**MONTGOMERY COUNTY HISTORIC PRESERVATION COMMISSION**  
**STAFF REPORT**

<b>Address:</b>	7054 Carroll Avenue, Takoma Park	<b>Meeting Date:</b>	3/11/2020
<b>Resource:</b>	Contributing Resource (Takoma Park Historic District)	<b>Report Date:</b>	3/4/2020
<b>Applicant:</b>	Sam and Bobbi Kittner (Rick Vitullo, Architect)	<b>Public Notice:</b>	2/26/2020
<b>Review:</b>	HAWP	<b>Tax Credit:</b>	No
<b>Case Number:</b>	37/03-19CC REVISION	<b>Staff:</b>	Michael Kyne
<b>PROPOSAL:</b>	Egress stairs

## Rear Stair Addition for:

# 7054 Carroll Avenue

# A-1

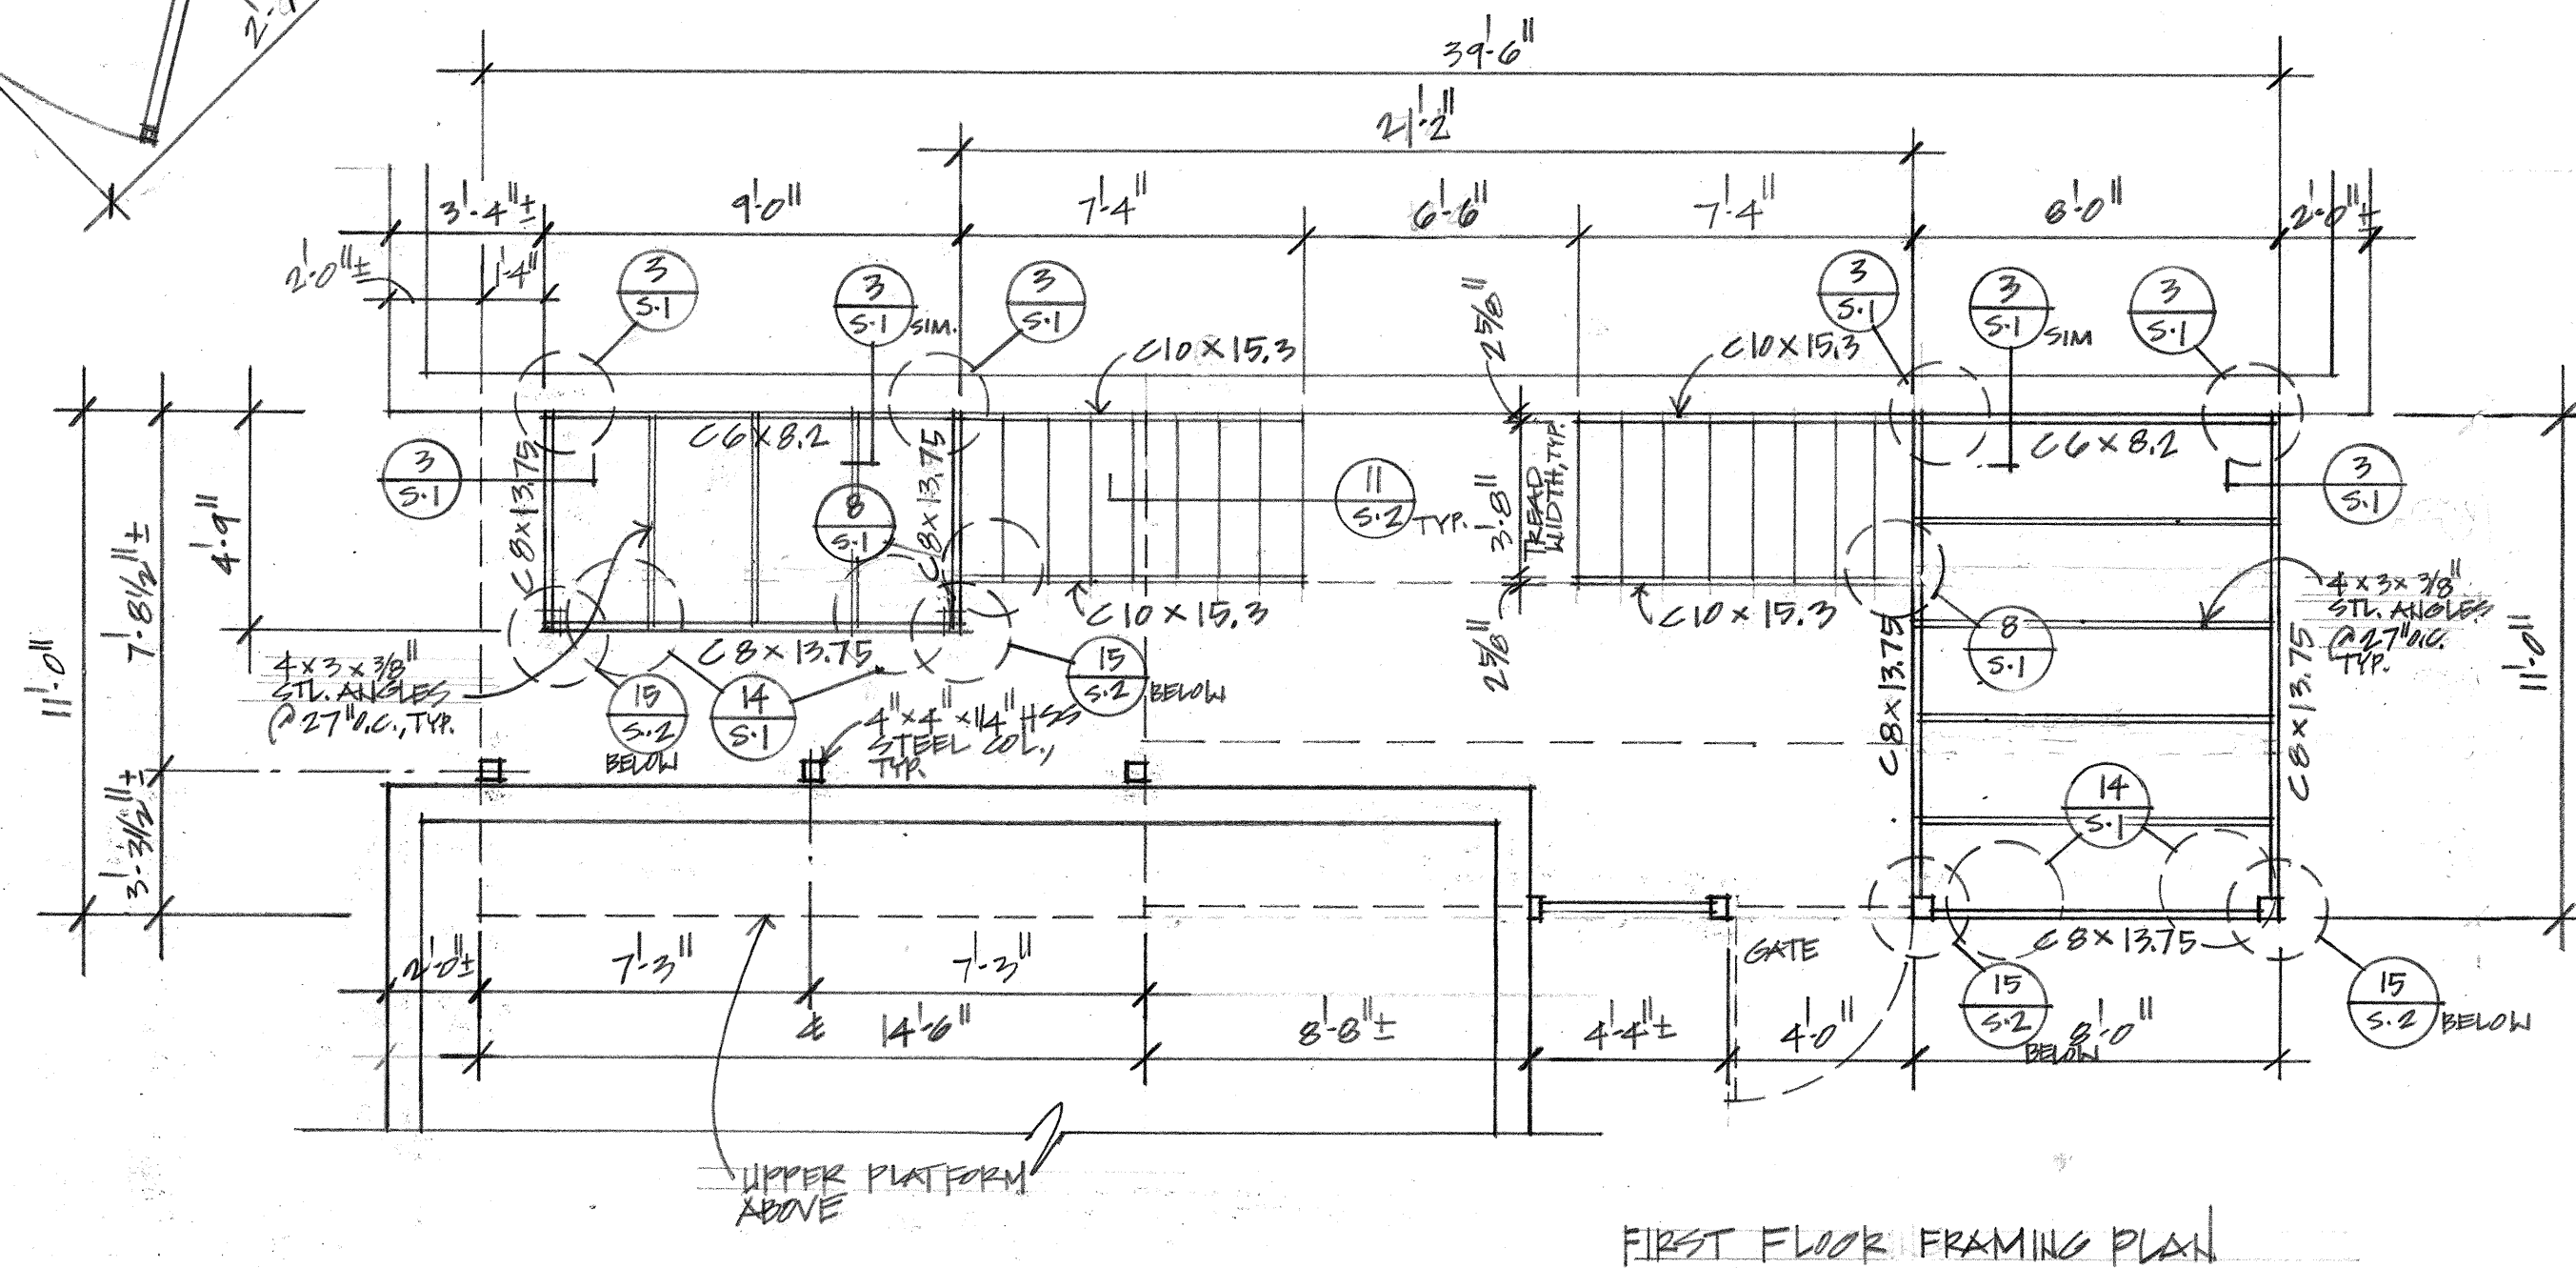
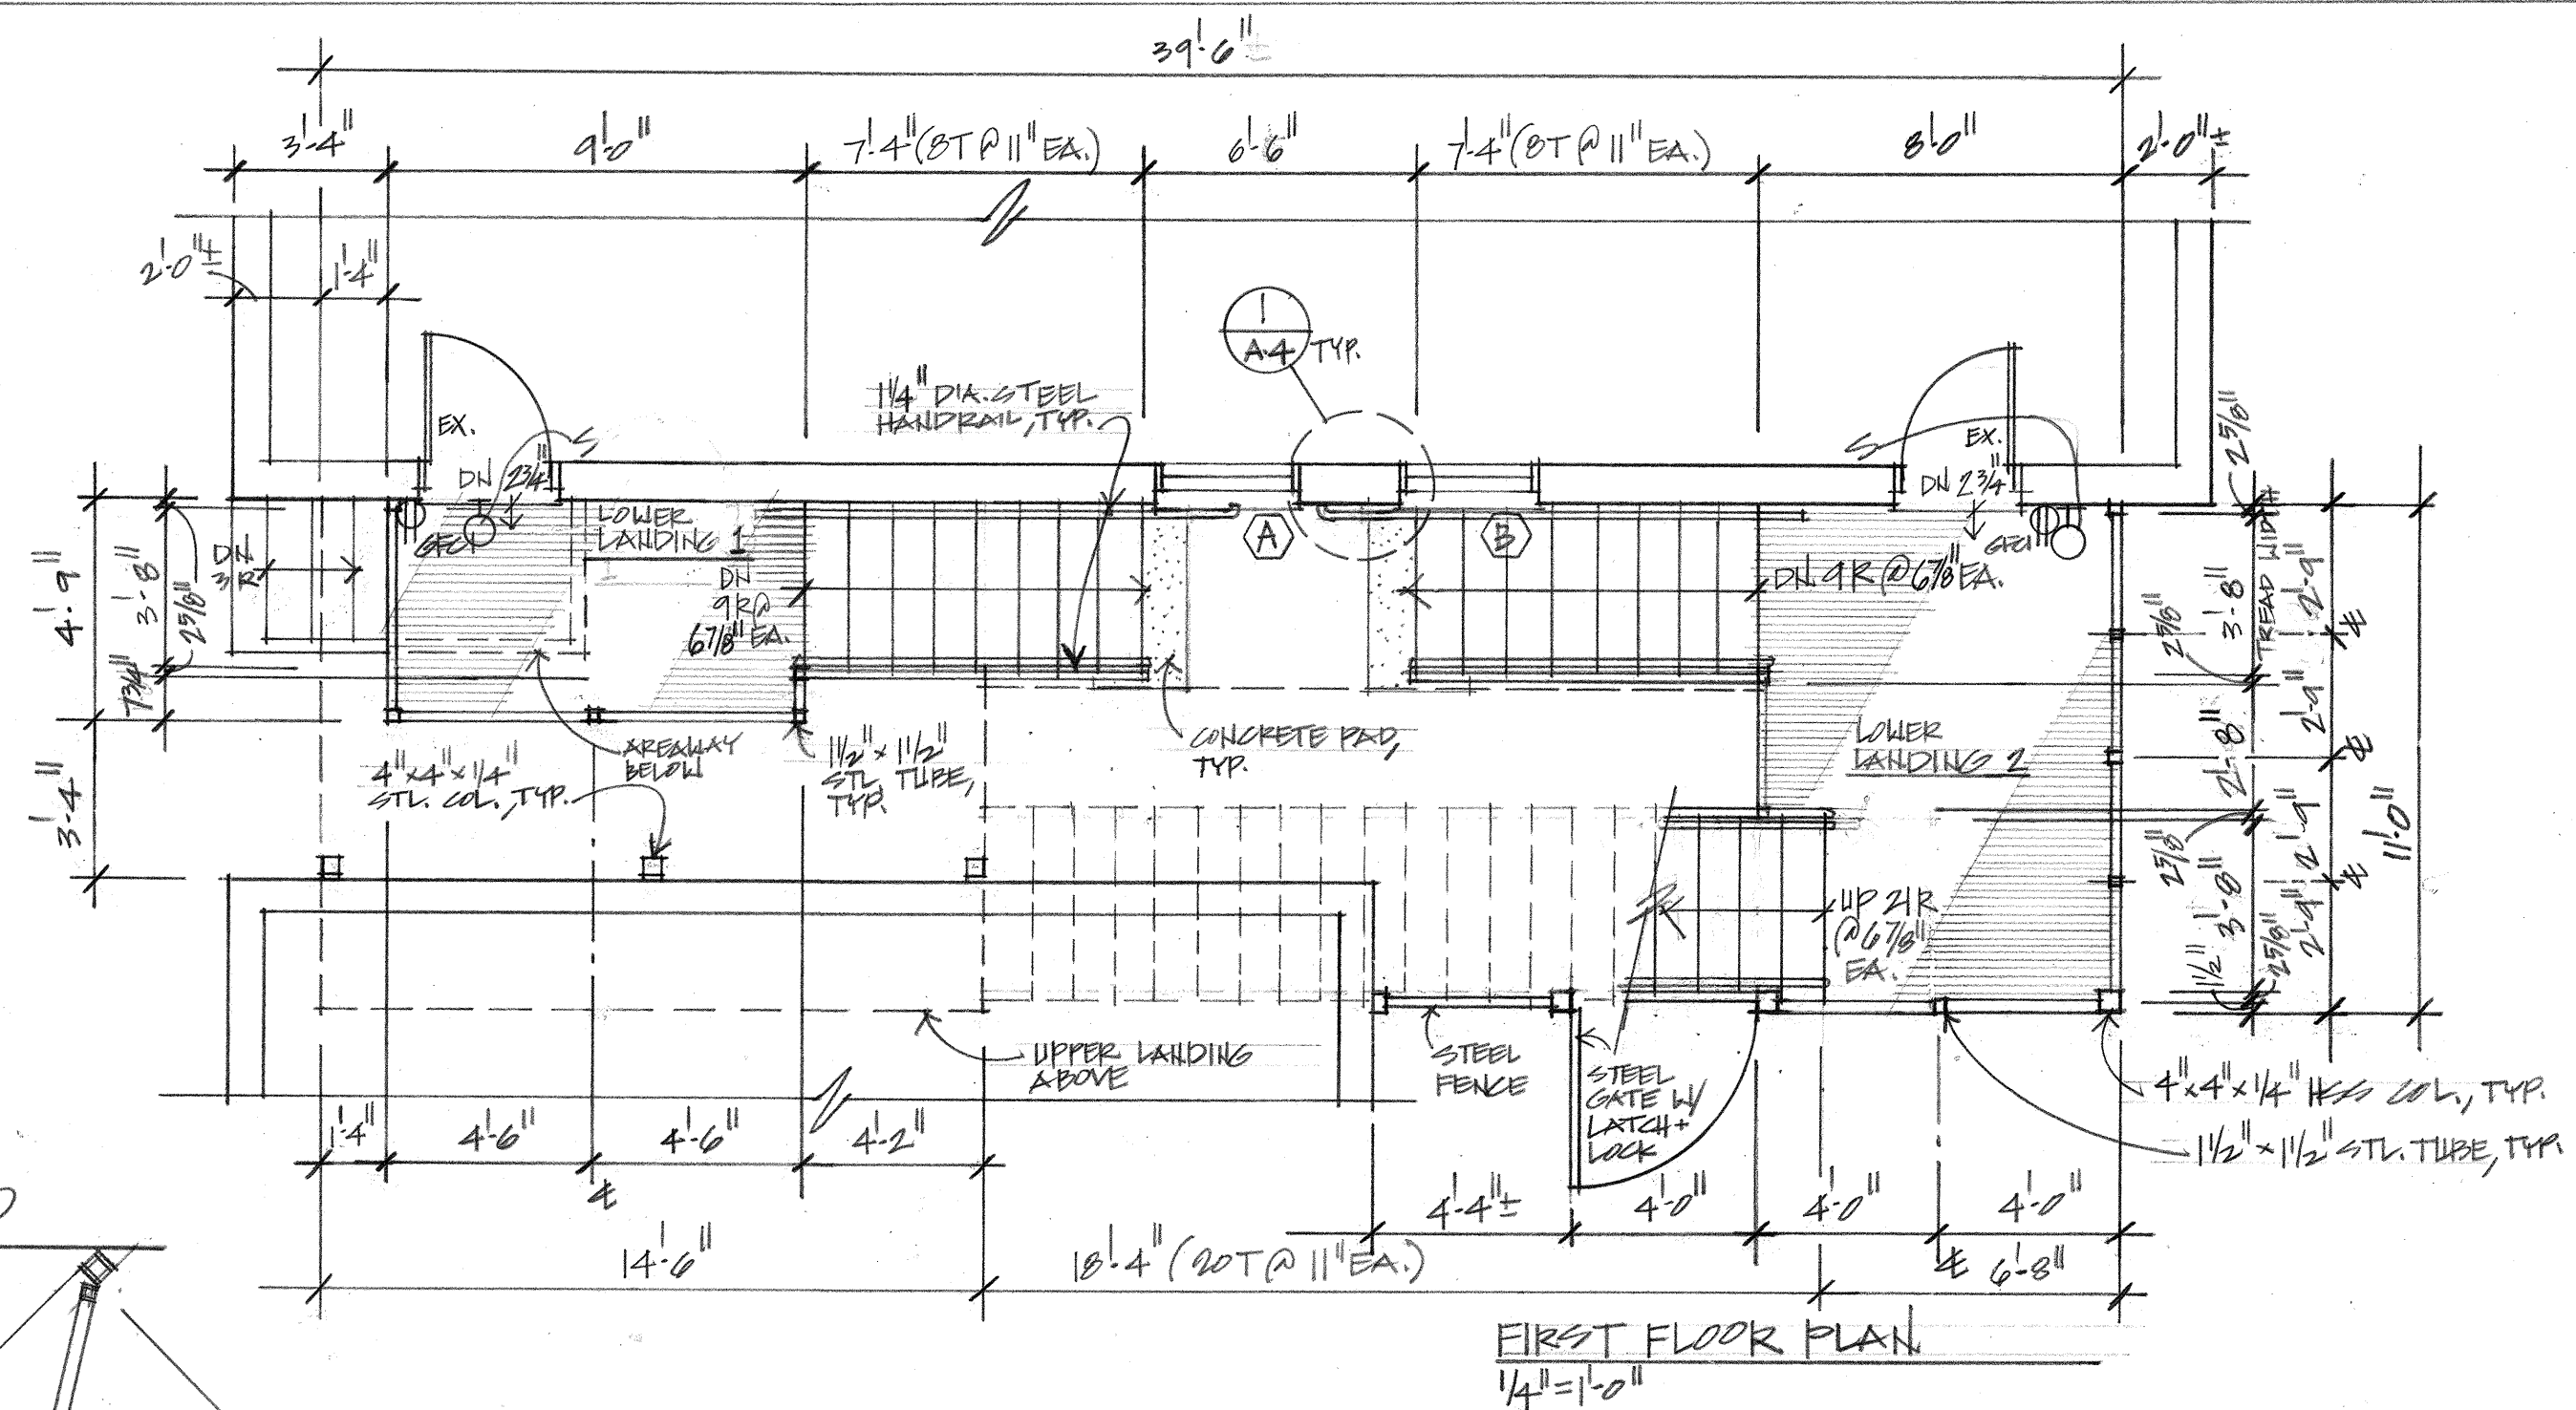
- ½” steel balusters are proposed in place of the previously approved wire mesh/cloth safety screening.
- Diamond patterned steel plate flooring is proposed in place of the previously approved open steel grate flooring.

Due to code requirements, the applicants have revised their application to propose diamond patterned steel plate flooring in place of the previously approved open steel grate flooring. Additionally, the applicants have revised their application to propose ½" steel balusters in place of the previously approved wire mesh/cloth safety screening for all landings and stairs, due to cost considerations. As revised, the previously approved wire mesh/cloth safety screening will be retained at the west side of the fire escape to serve as a plant trellis. It will be also be retained as screening for the vertical duct at the rear of the building.

1. **Flooring:** We had originally desired to have steel open grating for all of the horizontal floor surfaces, including the stair treads. Upon meeting with county code officials however we were told that that would not be code compliant. Only diamond patterned steel plate is compliant, which is what we are now using. (see attachment).
2. **Railings:** Because of availability of large quantities of material, and the familiarity of using this material by the local fabricator, the labor and material cost for using steel mesh was prohibitive to use everywhere. So, we had to eliminate the steel mesh at all of the landing and stair railings, except we did keep it at the west side as a planting "scaffolding" and as the vertical duct screening material. We have proposed using standard vertical ½" x ½" steel balusters at 4" o.c. for all landings and stairs.

NOTE:  
ALL TREADS ARE PRE-FAB STEEL 1/8" THICK  
(3' 8" WIDE) DIAMOND PLATE (FS INDUSTRIES)
